June 9, 2023

Site: 4719 86th Ave SE
Mercer Island, WA 98040
TPN: 7598100421
Area: 11,500 sq ft. = .26 acres

Re: RFI from John Kenney:

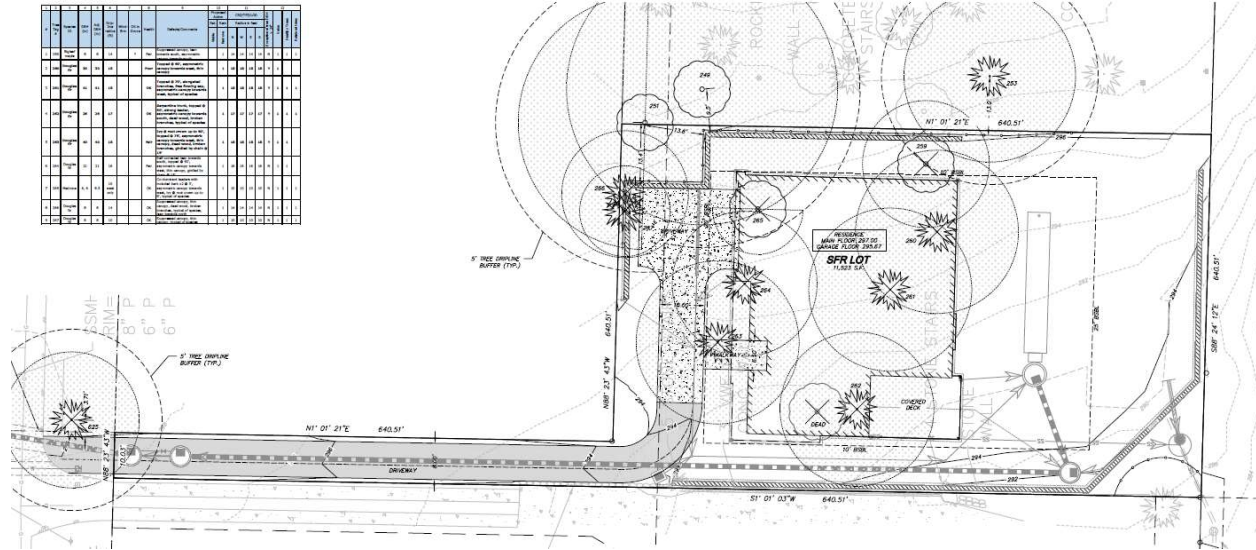
5. Provide the required form showing at least the minimum amount of required trees protected on site
HYPERLINK

"https://www.mercerisland.gov/sites/default/files/fileattachments/community_planning_amp_development/page/21988/mercerislandtreeinventory.pdf" mercerislandtreeinventory.pdf (See Architecture plans)
